**SCOPE OF WORK**  
**Design and Construction of**  
**Play Ground Shade Cover**  
**July 2016**  
**US EMBASSY DJIBOUTI**

Project Description :  
TENSILE FABRIC STRUCTURE  
21 X 21M  
Drawing Title :  
PLAN AND ELEVATION

# FAC NEC Play Ground Shade design & Construction project

## Playground Shade Bidders Questions and Answers

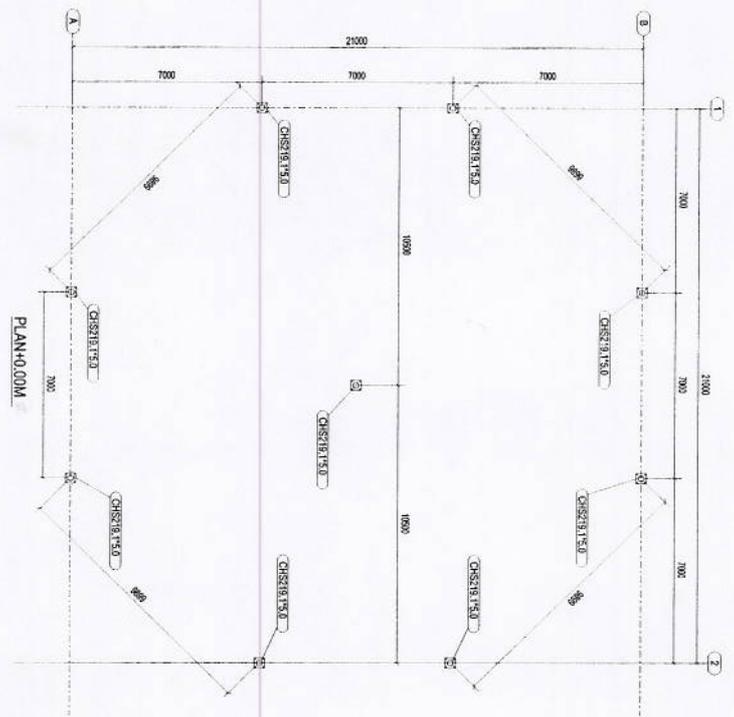
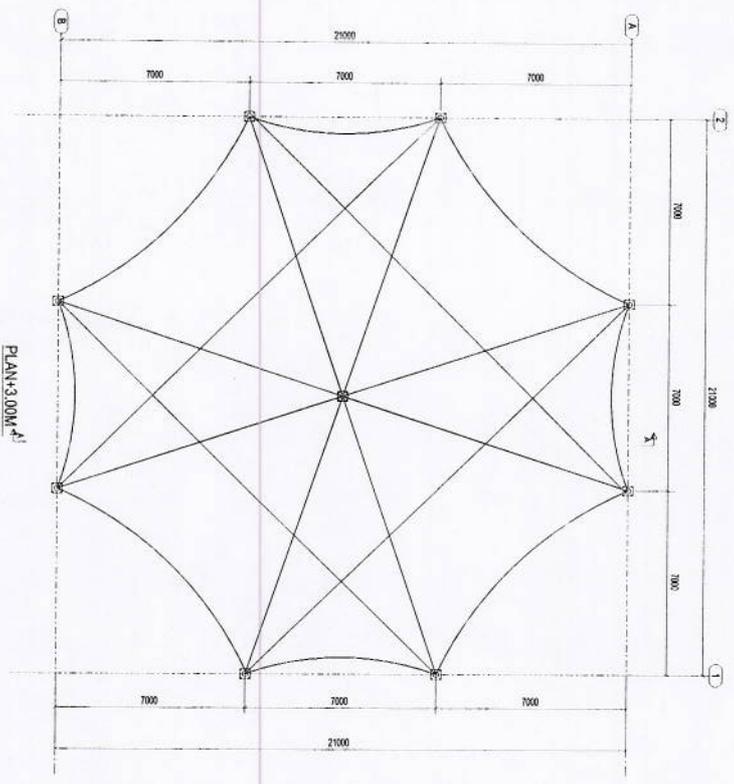
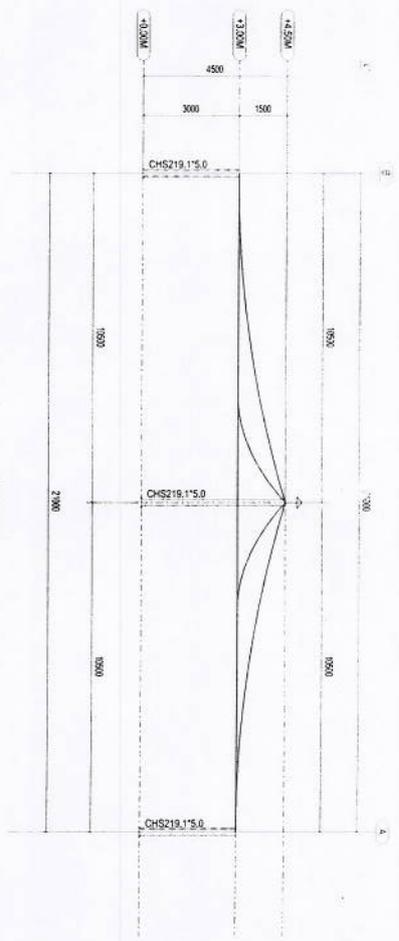
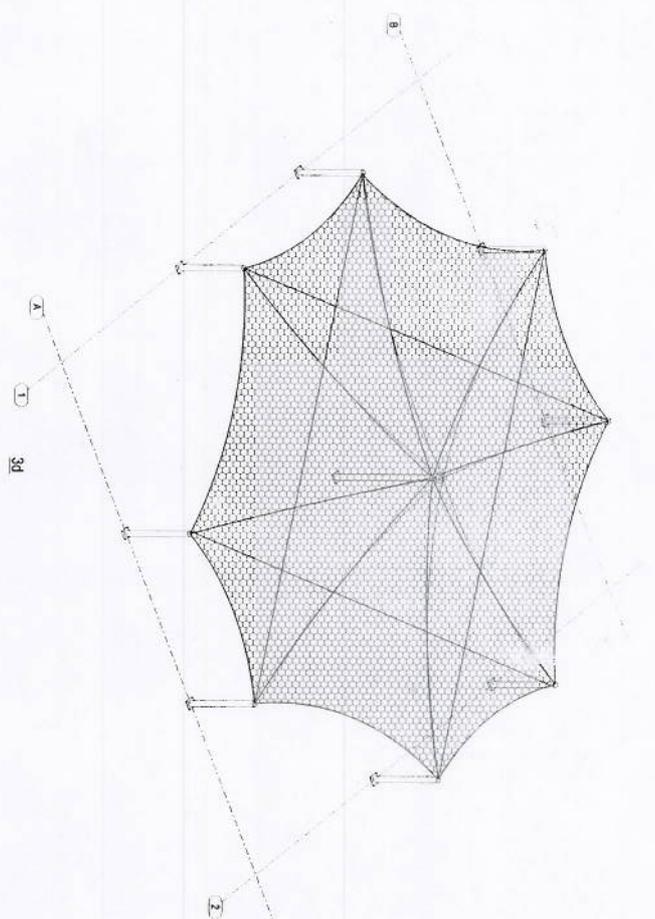
Q3. Provide dimensions of the existing poles. Length and diameter of the poles?

A3. Pole diameter is approximately 8 5/8 "and the pole height and the spacing is clearly indicated on the drawings attached on the SOW. For precise data, the contractors need to perform site measurement.
